UNITED STATES PATENT AND TRADEMARK OFFICE

APPLICATION NO.	FILING DATE	FIRST NAMED INVENTOR	ATTORNEY DOCKET NO.	CONFIRMATION NO.
10/522,931	01/24/2005	Alfred Losch	71657	6637
23872	7590	07/28/2006		
MCGLEW & TUTTLE, PC P.O. BOX 9227 SCARBOROUGH STATION SCARBOROUGH, NY 10510-9227			EXAMINER AMIRI, NAHID	
			ART UNIT	PAPER NUMBER
			3679

DETAILED ACTION

FIG. 3

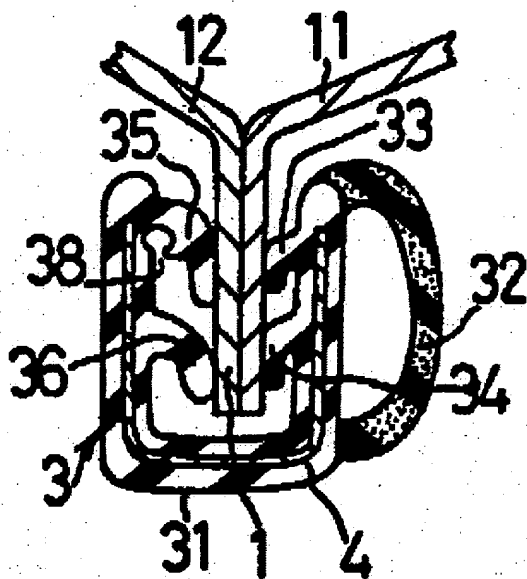
With respect to claim 1, Hayashi et al. disclose a connection (Fig. 3) of outer and inner sheets (11, 12) each sheet (11, 12), having an edge, wherein the edges of the sheets (11, 12) have at least partially planar contact and can be detachably connected with one another, the connection comprising flanges associated with the areas of the edges of said sheets (11, 12) lying on top of each other, wherein the flanges are bent in the same direction and a detachable connection of the sheets (11, 12) by means of a clamping strip (3).

With respect to claim 2, Hayashi et al. disclose (Fig. 3) that the clamping strip (3) has an at least partly U-shaped design.

With respect to claim 3, Hayashi et al. disclose (Fig. 3, column 3, lines 8-12) that the clamping strip consists of a plastic.

With respect to claim 7, Hayashi et al. disclose that the connection (Fig. 3) further includes a joint sealing (32) integrated in the clamping strip (3).

With respect to claim 8-9, Hayashi et al. disclose (Fig. 3) that the clamping strip (3) capable of being designed at the same time as an outer sealing (32); and wherein the clamping strip (3) extends fully over the circumference of the edges of the sheet (11, 12).

FIG. 10

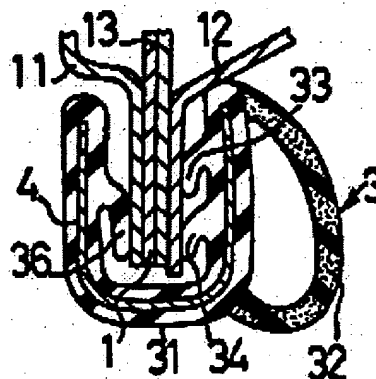
With respect to claim 4, Hayashi et al. disclose (Fig. 10) that the clamping strip (3) has a metal core (4).

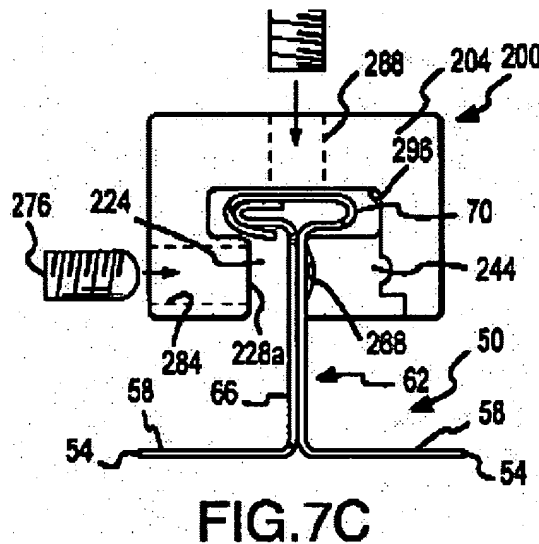
With respect to claims 1 and 10, Haddock disclose a connection (Fig. 7C) of outer and inner sheets (54), each sheet (54) having an edge, wherein the edges of the sheets (54) have at least partially planar contact and can be detachably connected with one another, the connection comprising flanges (66) associated with the areas of the edges of said sheets (54) lying on top of each other that are bent in the same direction and a detachable connection of the sheets (54) by means of a screw connection (276), and a clamping strip (200) providing a detachable connection of the sheets (54) at the flanges.

With respect to claims 2 and 11, Haddock disclose (Fig. 7C) that the clamping strip (200) has an at least partly U-shaped design.

With respect to claims 5 and 6, Haddock discloses (Fig. 7C) that the clamping strip (200) and the edges (66) of the sheets (54) are connected to one another by means of the screw connection (276).

With respect to claims 8 and 9, Haddock disclose (Fig. 7C) that the clamping strip (200) capable of being designed at the same time as a cover strip (not shown); and wherein the clamping strip (200) extends fully over the circumference of the edges of the sheet (54).

With respect to claim 15, Haddock discloses a connection (Fig. 7C) further having a joint sealing (constituted by the concave portion of the inner sidewall of the clamp 200) connected together with the clamping strip (200) and the edges (66) of the sheets (54) to be connected by means of the screw (276).

With respect to claim 16, Haddock discloses (Fig. 7C) that a joint sealing (constituted by the concave portion of the inner sidewall of the clamp 200) integrated in the clamping strip (200).

With respect to claims 17 and 18, Haddock discloses (Fig. 7C) that the clamping strip (200) capable of being designed at the same time as a cover strip (not shown); and wherein the clamping strip (200) extends fully over the circumference of the edges of the sheet (54).
